**U.S. ARMY ENGINEER DIVISION
HUNTSVILLE, ALABAMA**

**REVISED FINAL
PROPOSED PLAN FOR
The ABANDONED DEACTIVATION FURNACE (SEAD-16)
and the ACTIVE DEACTIVATION FURNACE (SEAD-17)
SENECA ARMY DEPOT ACTIVITY
ROMULUS, NEW YORK**

DECEMBER 2003

Response to Comments

**FIGURE 2
 SEAD-16 REMEDIATION AREA
 (SOIL EXCEEDING CLEANUP GOALS)**

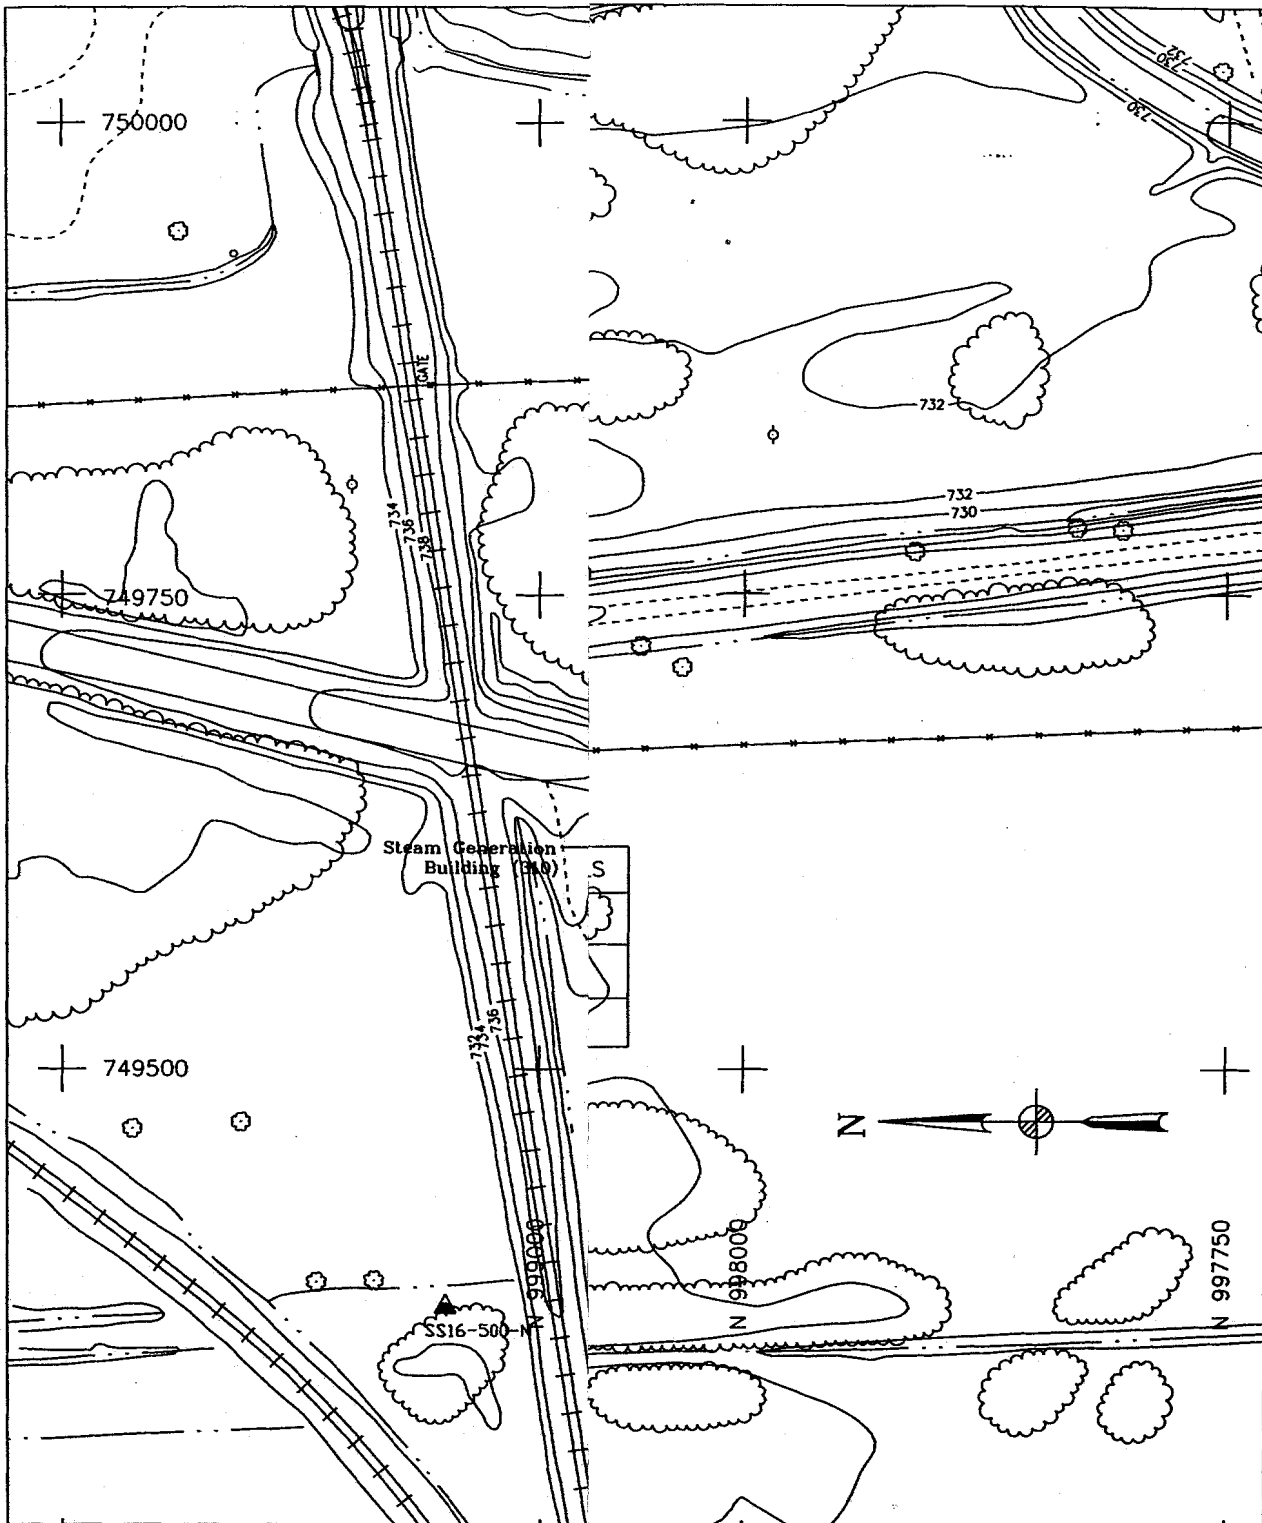
Although it is stated in the response that Figure 2 has been added to show areas of proposed remediation including the previous "hotspot" areas, the area around SS16-31 still is not included in Figure 2. Revision of Figure 2 is needed.

Response 24: As stated in response to Comment #1, cleanup goals for PAHs and metals have been developed and, consequently, the remedial area has expanded. Therefore, the concept of "hotspots" no longer exists. All locations that include concentrations that exceed the cleanup goals are included in the remedial area, and the remedial action is driven by compliance with the established cleanup goals. It should be noted that all areas formerly referred to as "hot spots" are included in the revised remedial area based on exceedances of cleanup goals. Figures 2 and 3 have been revised to illustrate the extent of the remedial area.

Response 29: As stated in response to Comment #1, cleanup goals for PAHs and metals have been developed and, consequently, the remedial area has expanded. Therefore, the concept of “hotspots” no longer exists. All locations that include concentrations that exceed the cleanup goals are included in the remedial area, and the remedial action is driven by compliance with the established cleanup goals. Figures 2 and 3 have been revised to illustrate the extent of the remedial area.

**FIGURE 3
 SEAD-17 REMEDIATION AREA
 (SOIL EXCEEDING CLEANUP GOALS)**

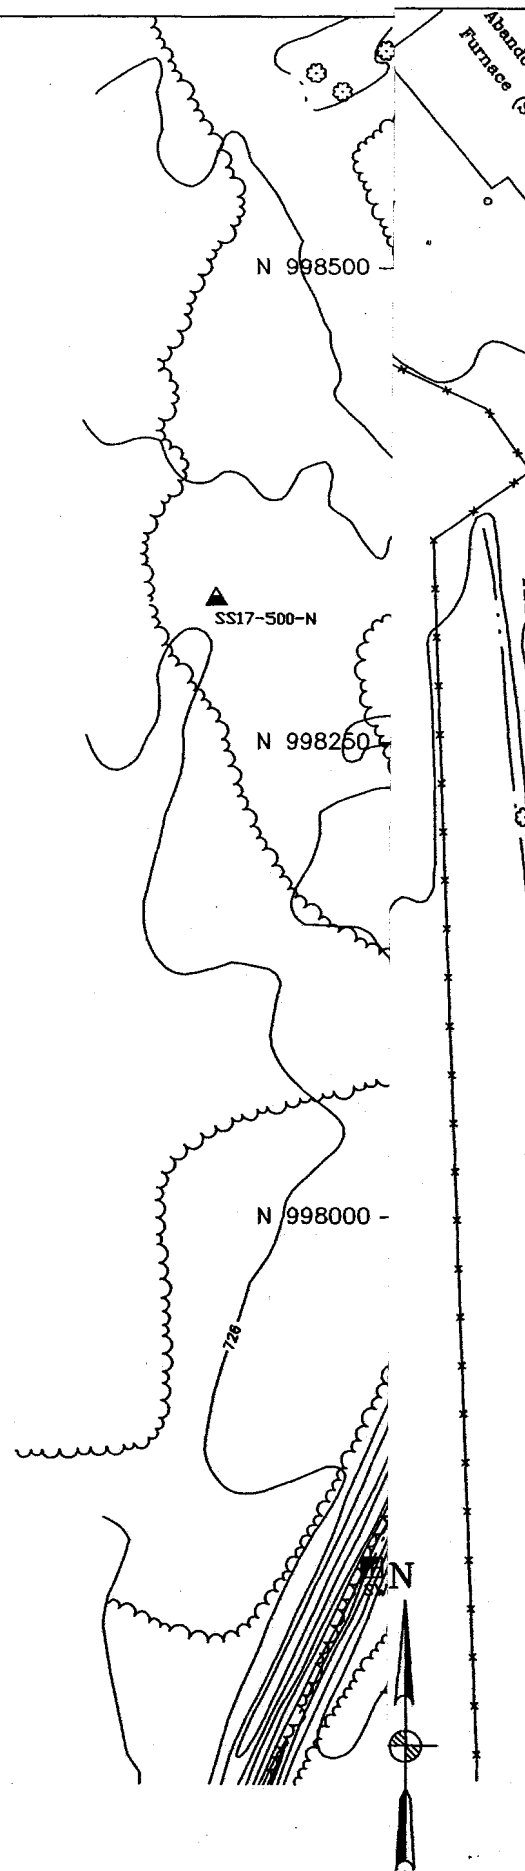
Comment 15: Figure 3
